**Region A Headquarters**  
**56 Game Farm Road, Gray ME 04039**  
**ADDENDUM NUMBER 3r1**  
**October 14, 2016**

### **Region A Headquarters, dated August 29, 2016**

1. A600 – Reissued – Revise door schedule, Add GL2- clarification.
2. A601 – Reissued – Revise SF1- lobby, Add Detail 4.
3. A900 – Reissued – Add door schedule, Add window Schedule.

## SUBSURFACE WASTEWATER DISPOSAL PLAN

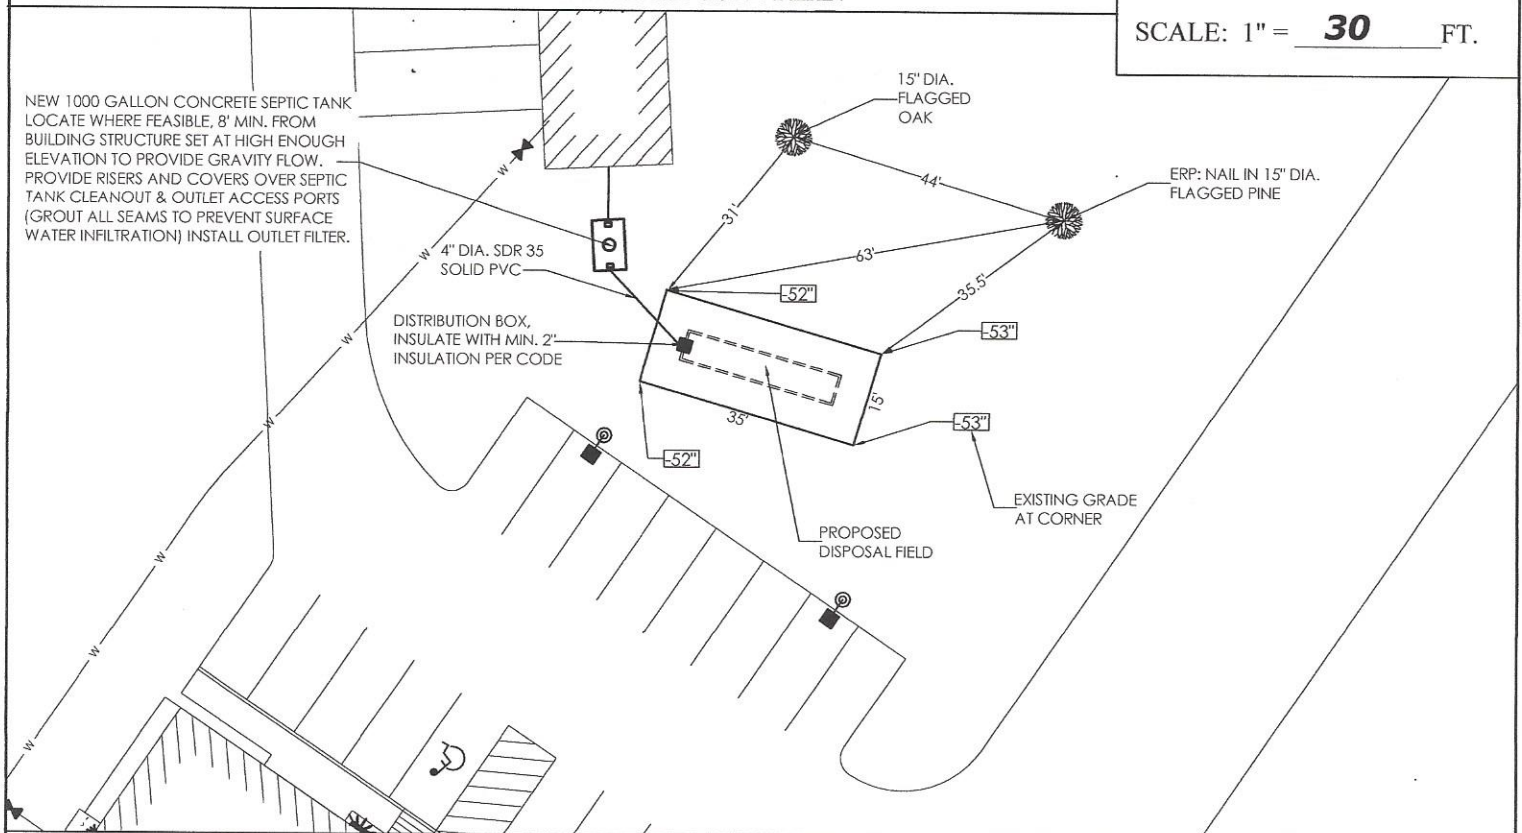
1. Attached please see bunkhouse septic design for reference.

NEW 1000 GALLON CONCRETE SEPTIC TANK  
LOCATE WHERE FEASIBLE, 8' MIN. FROM  
BUILDING STRUCTURE SET AT HIGH ENOUGH  
ELEVATION TO PROVIDE GRAVITY FLOW.  
PROVIDE RISERS AND COVERS OVER SEPTIC  
TANK CLEANOUT & OUTLET ACCESS PORTS  
(GROUT ALL SEAMS TO PREVENT SURFACE  
WATER INFILTRATION) INSTALL OUTLET FILTER.

GL2 - CLARIFICATION  
1/4" = 1'-0"

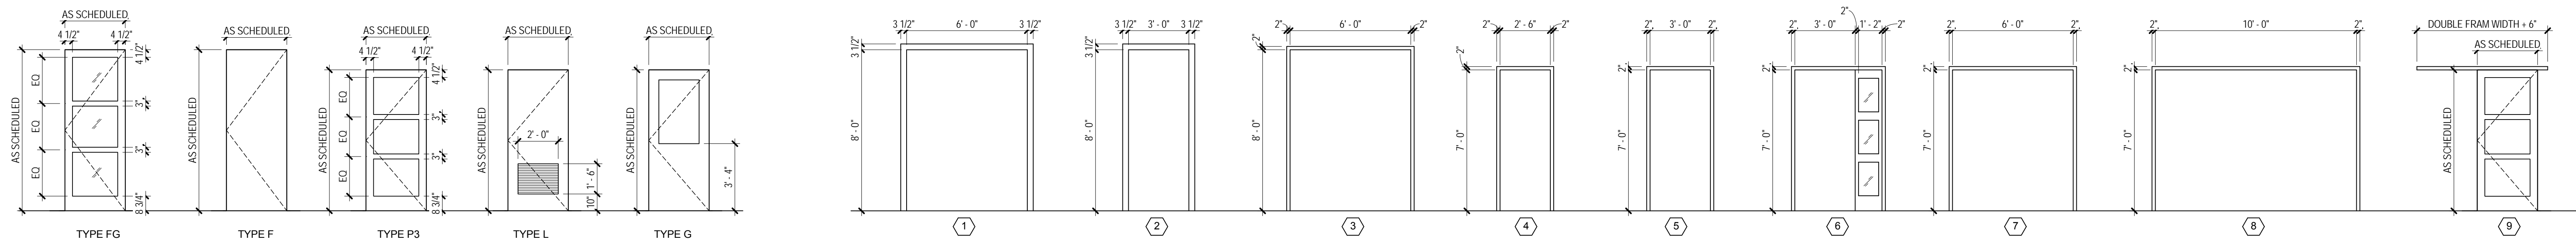
- 20. Question:** There are several Doors listed as Elevation P3 on the Door Schedule sheet A600. It looks like the intent was for P-3 to be a 3 panel and FG to be a 3 lite. In the material column of several of the P-3 Doors you list GL 1 or GL 2./HM Please clarify. Is there a cross section of the P 3 Door Panel? Is the intent for Applied Plants or a steel panel in lieu of glass?

**Answer:** The intent listed above is correct P-3 is intended as a 3 panel and FG is a 3 lite. The doors previously listed as P3 with GL1 or GL2 where designating glassing for the frame. The Door schedule has been correct and attached.

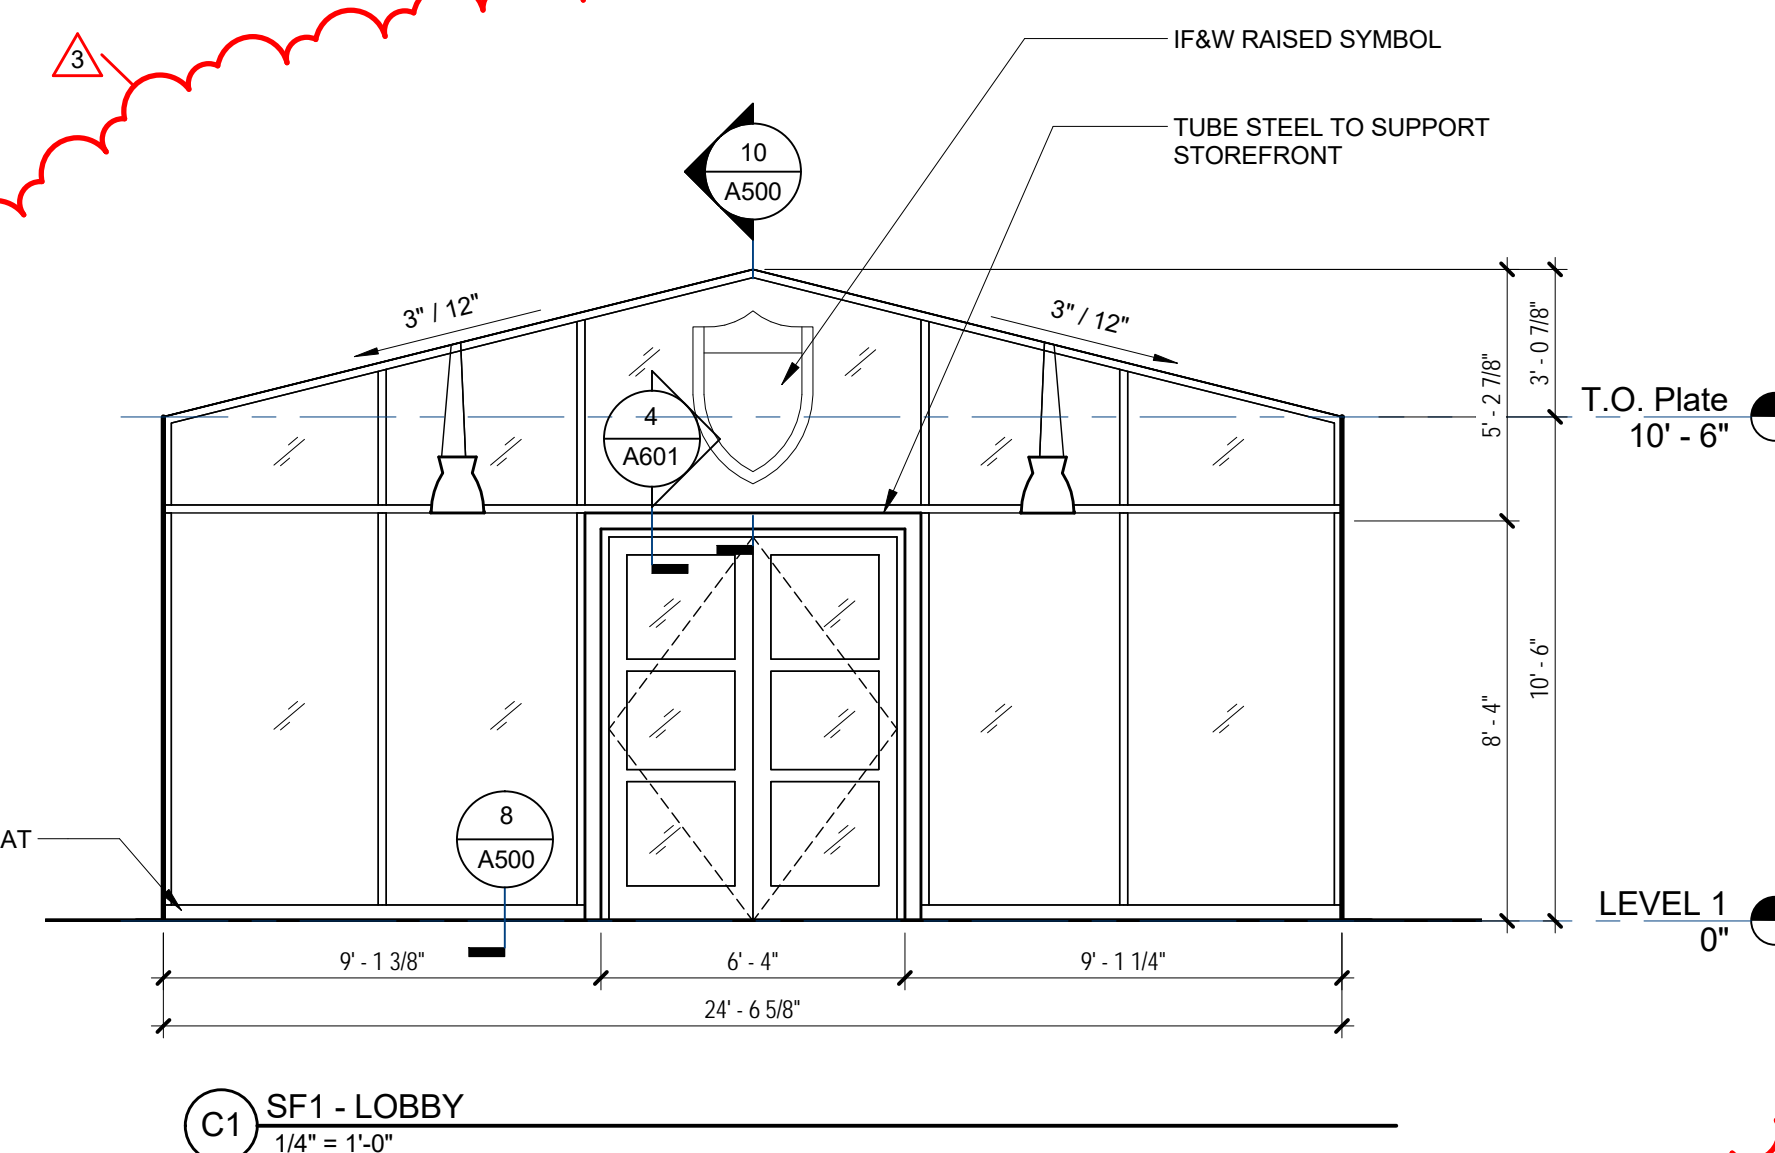
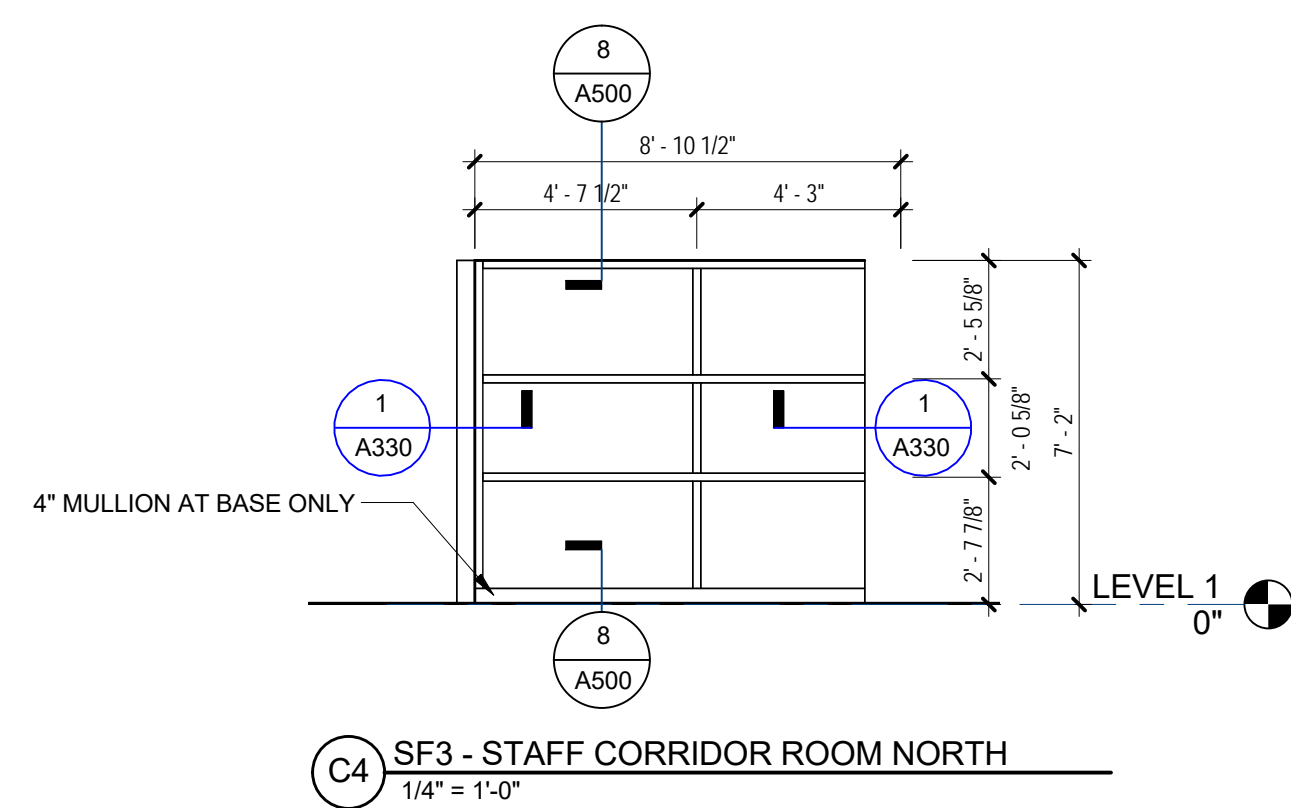
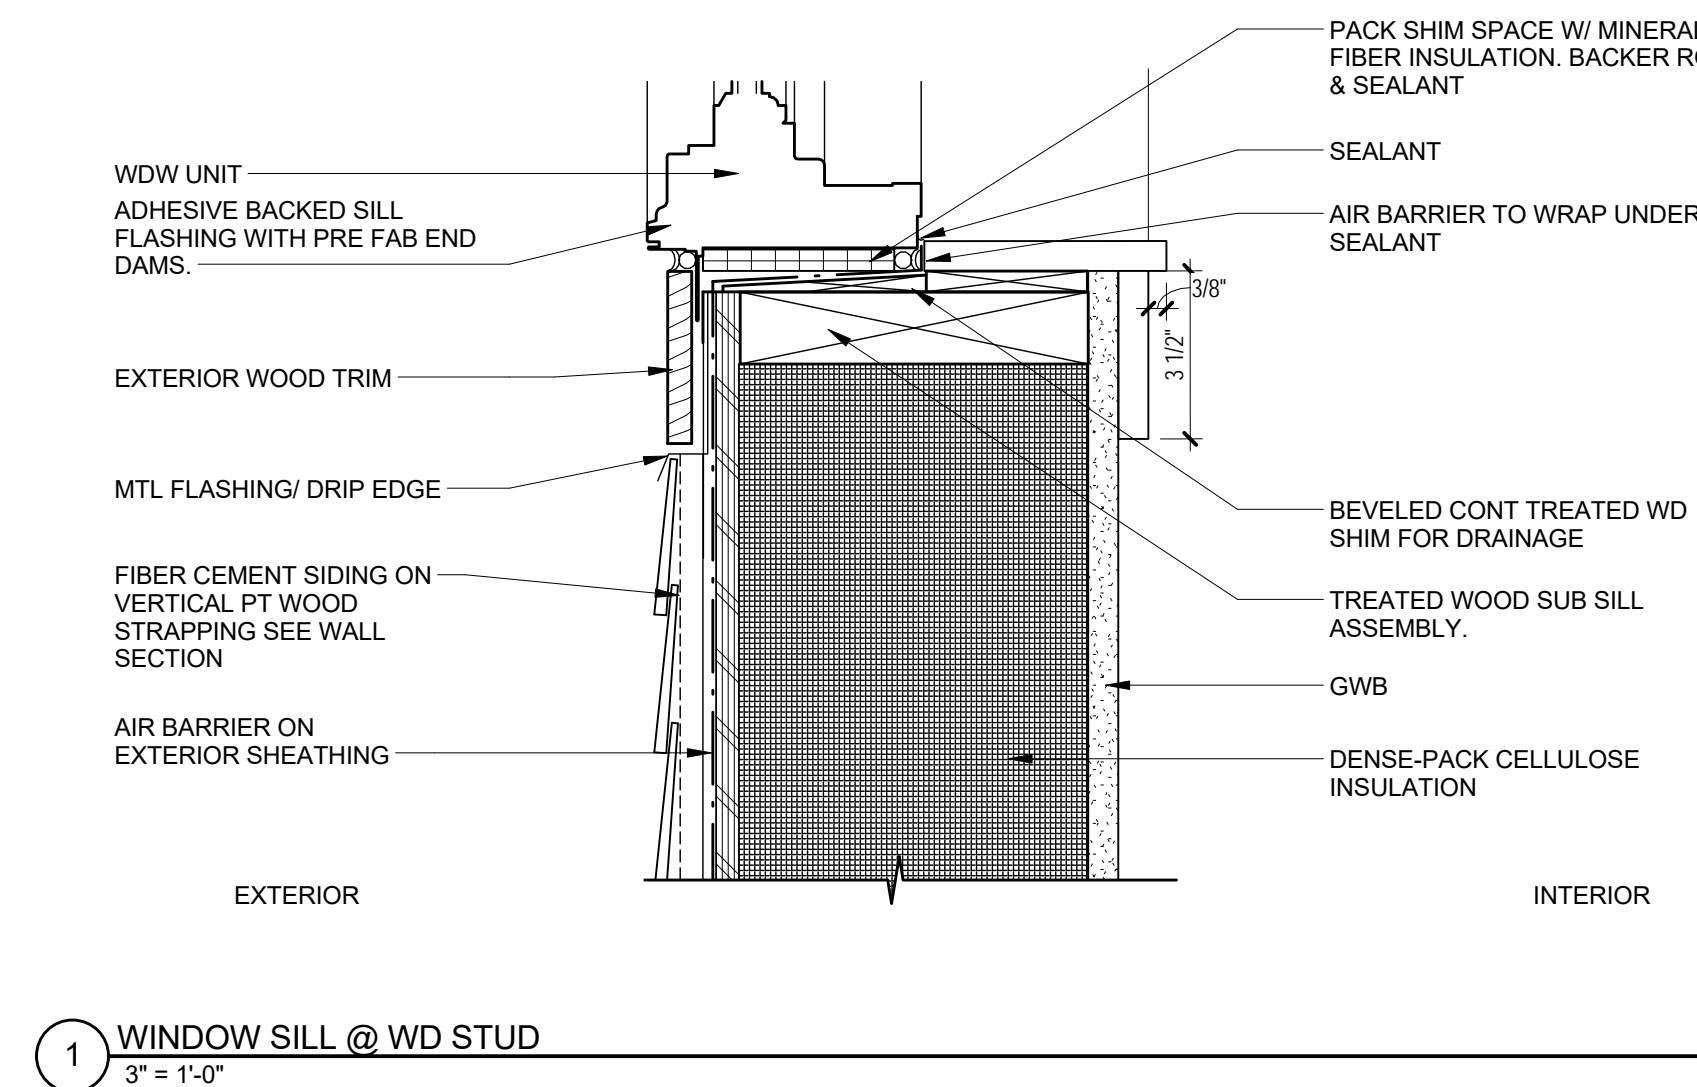
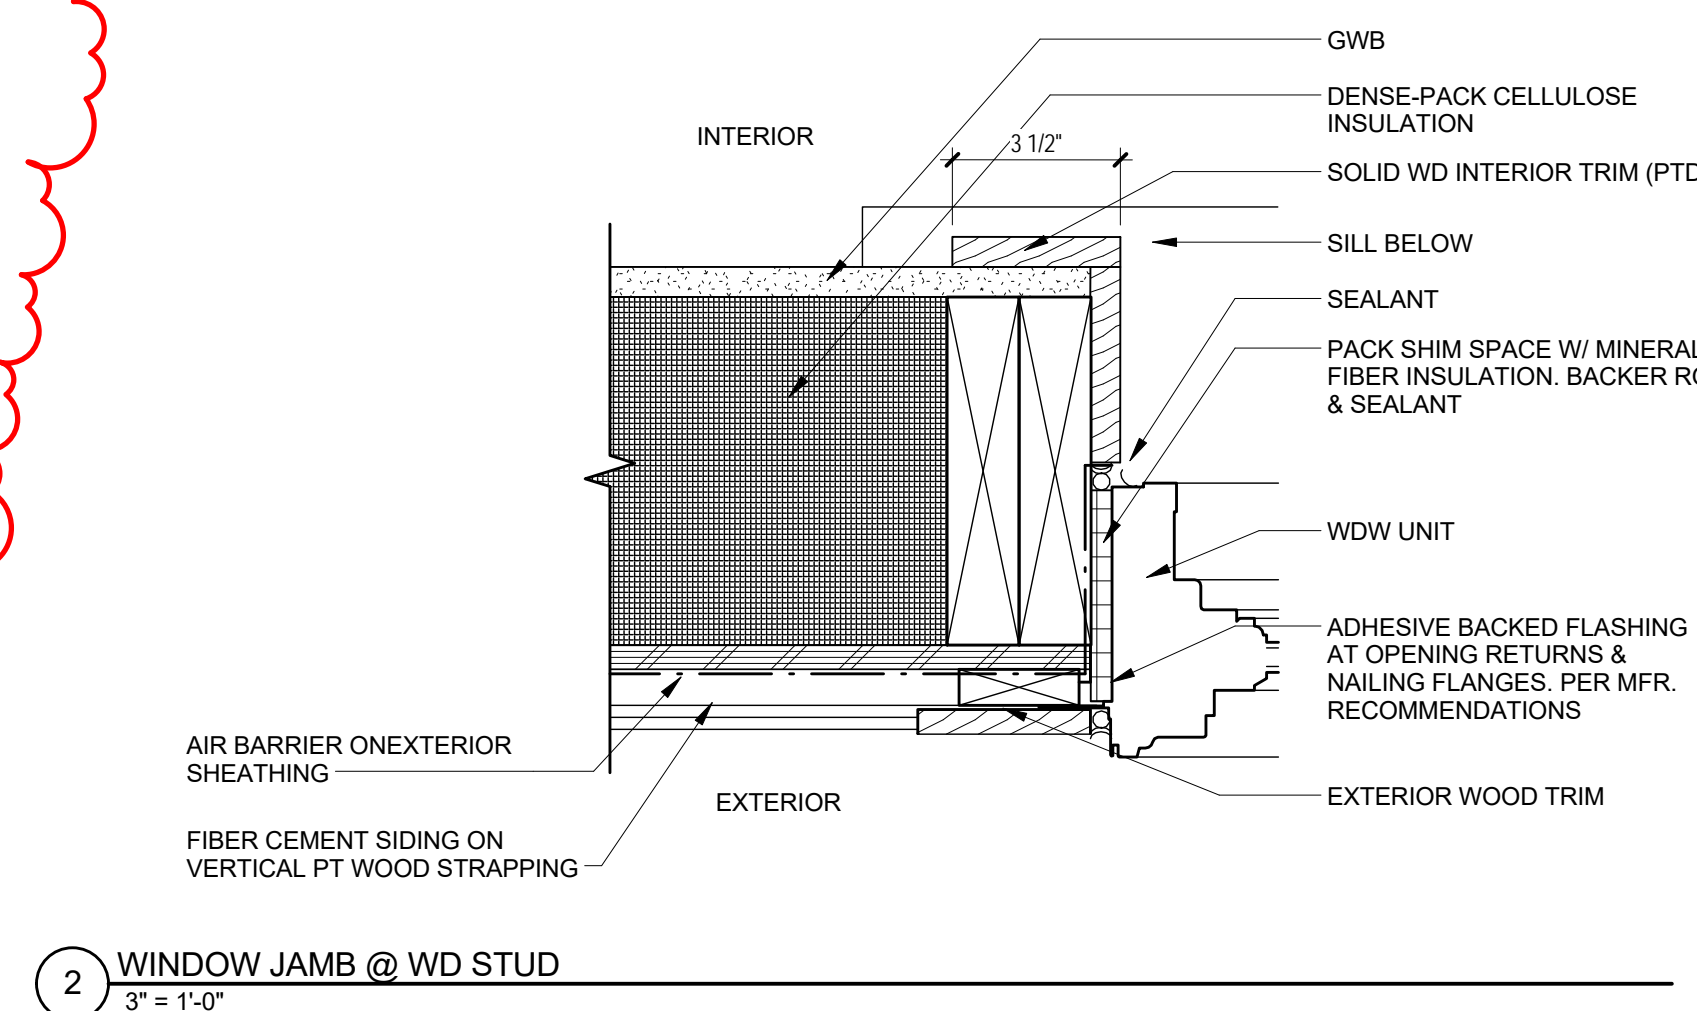
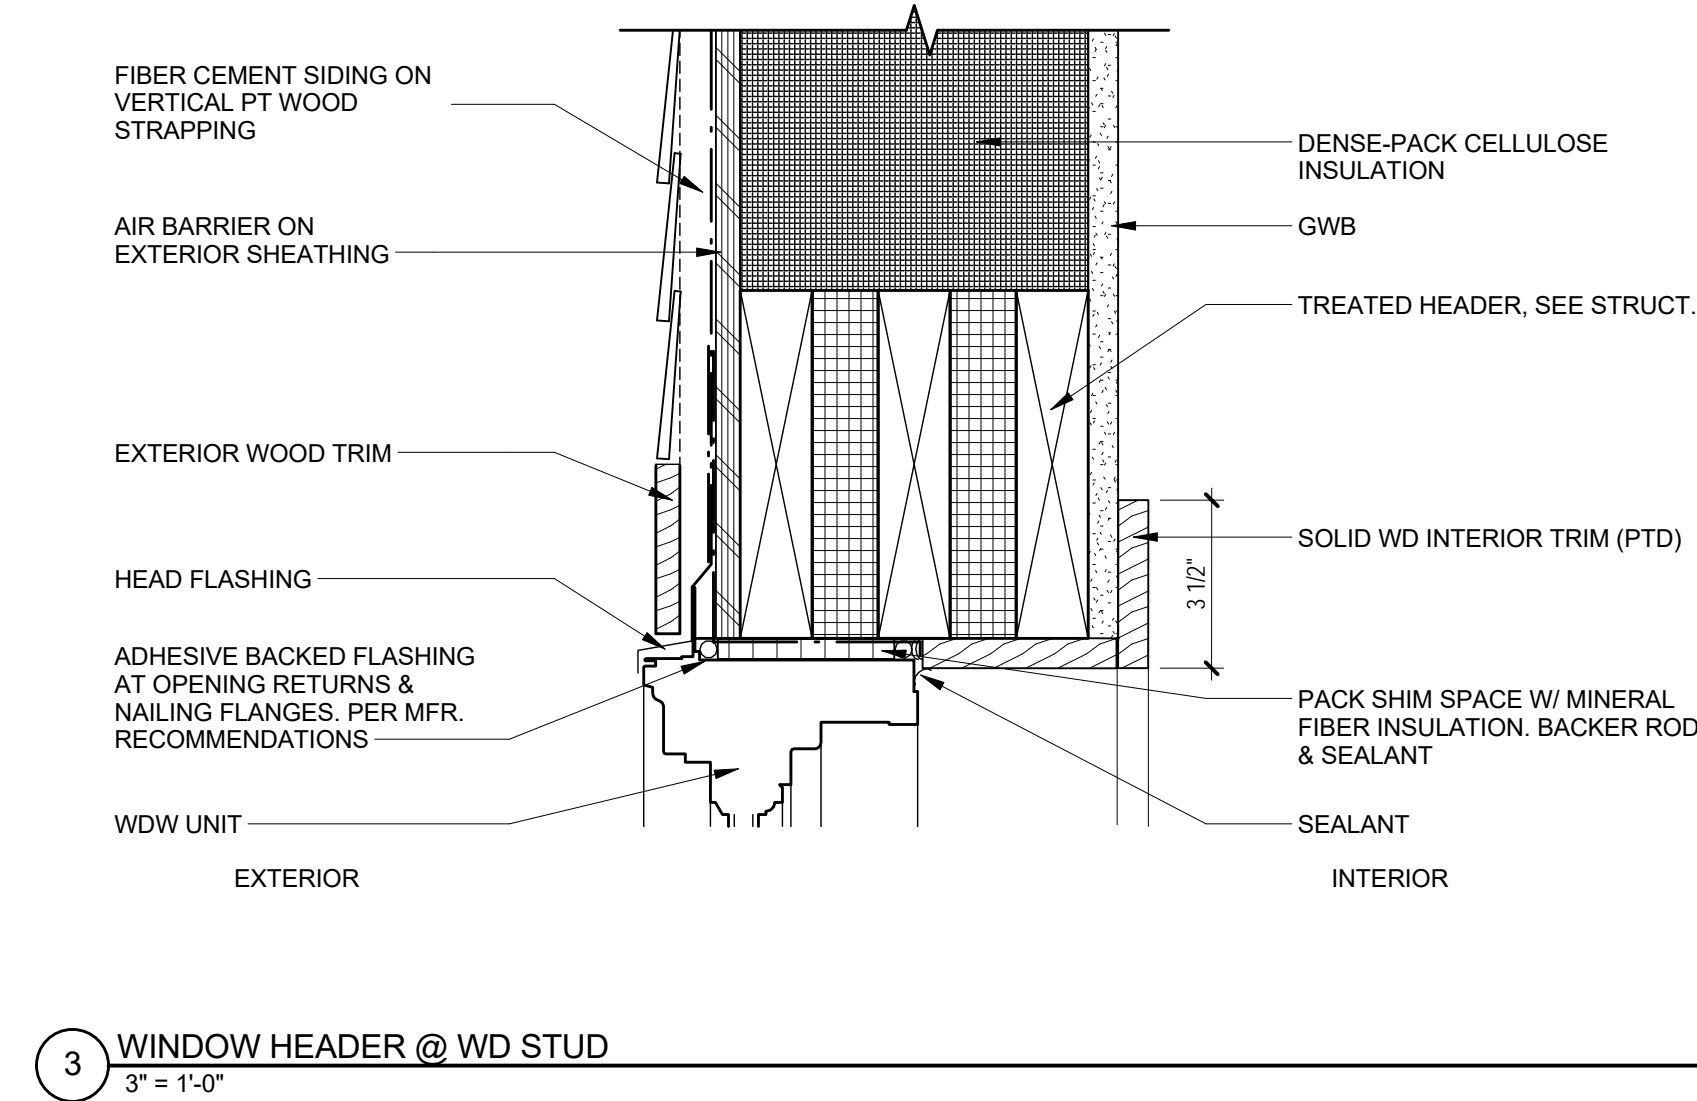
**Answer:** Door 101.1 is to have HW set 3 as laid out in 087100
15. **Question:** Regarding the doorframe in storefront SF1: as drawn and specified the manufacturers wont build the door frame. The large piece of transom glass would be too heavy for the storefront door header.

**Answer:** Provide tube steel structure as shown on REVISED A601 corners to be continuous welds full perimeter, finish steel in accordance to AESS category 4 prime and paint color to be selected by architect. Base plate details to be installed in accordance with detail B1/SB100. Use 1/2" base plate and base plate details shown on E5/SB100.
